SUBSURFACE WASTEWATER DISPOSAL SYSTEM APPLICATION

Town Or Plantation	Augusta
Street Division Lot #	Route 3 No Bellast Ave

Last: Garside, Sr First: William H.

This permit to amend Permit # 16357 issued 6/9/89. [signature] 7-31-89

SUBSURFACE WASTEWATER DISPOSAL PLAN

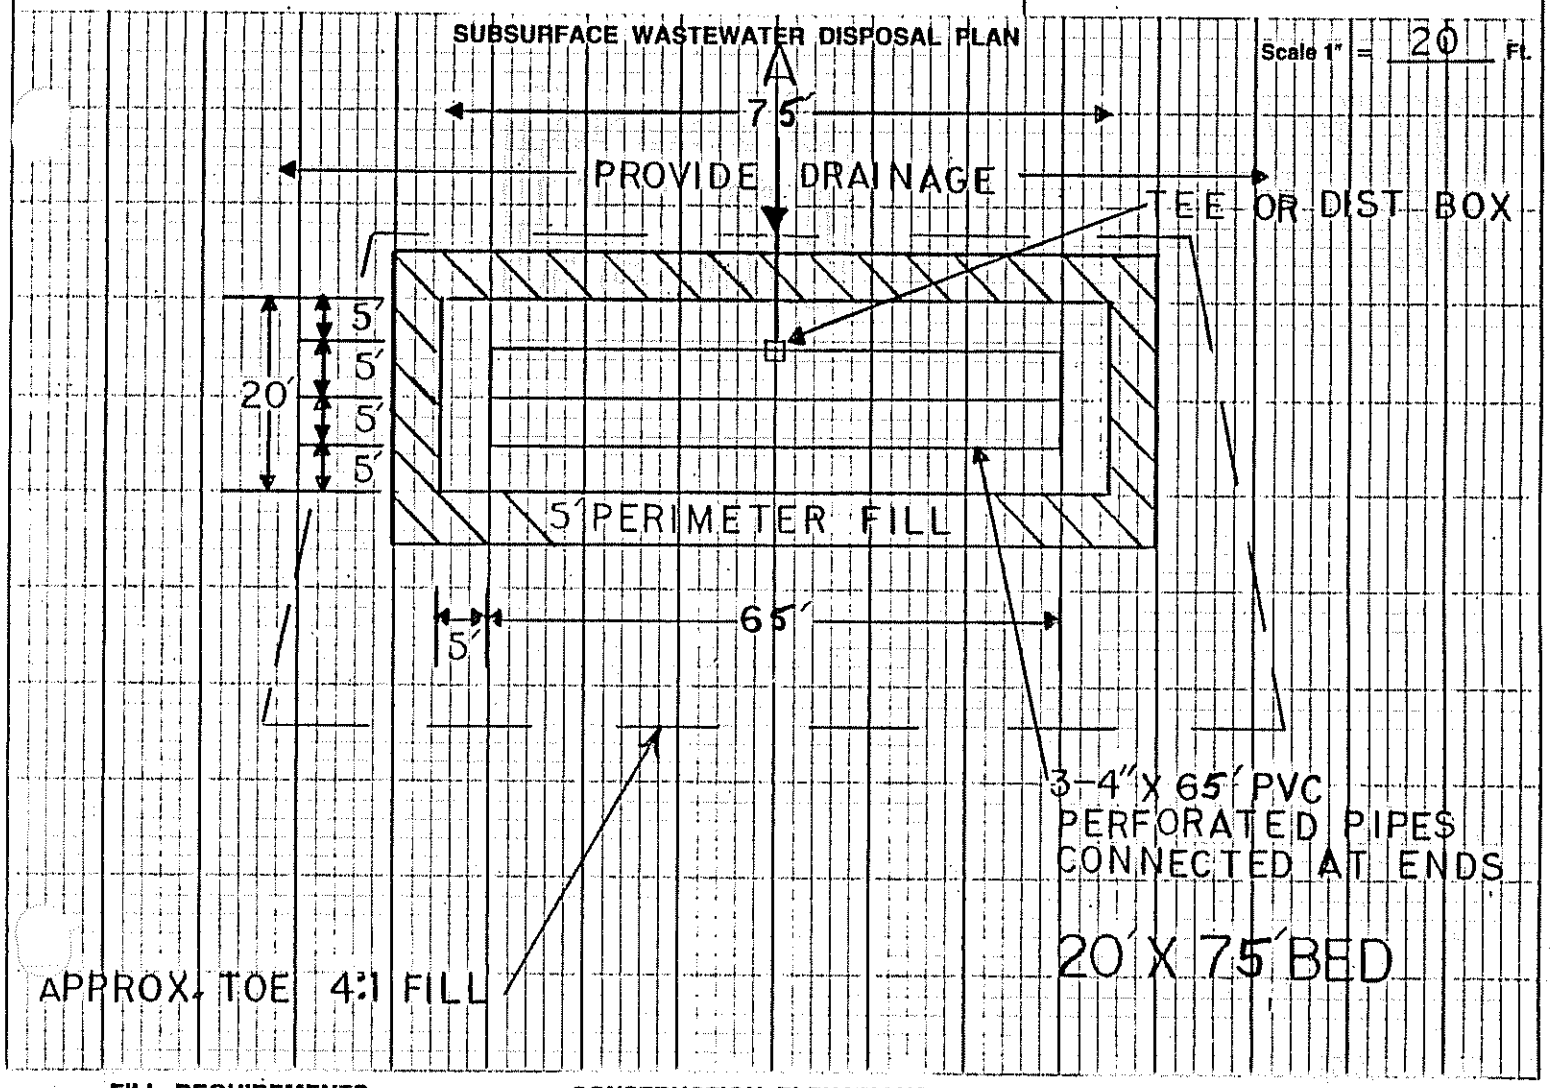
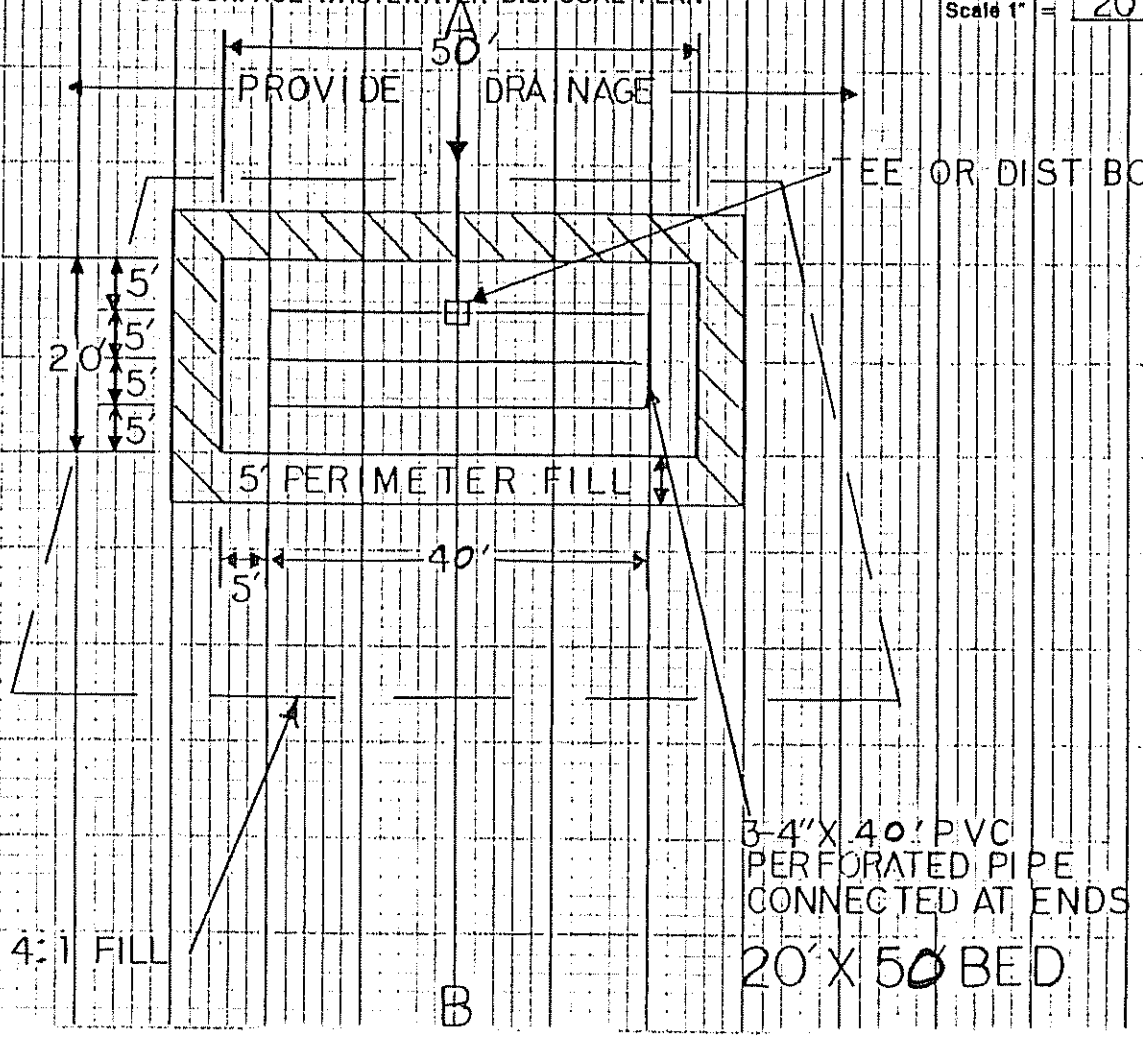
This set changed. See back set. 7-31-89

~~2 Bedroom~~
3 Bedroom
William W. Rideout gave me a verbal O.K. for the above change. Phone conversation 7/31/89 3:07 P.M.
[signature]

SIZE 1000 GALS.

DESIGN FLOW: 300 (GALLONS/DAY)

1. ■ BED 1000 Sq. Ft.
2. ☐ CHAMBER _____ Sq. Ft. ☐ REGULAR ☐ H-20
3. ☐ TRENCH _____ Linear Ft.
4. ☐ OTHER: _____
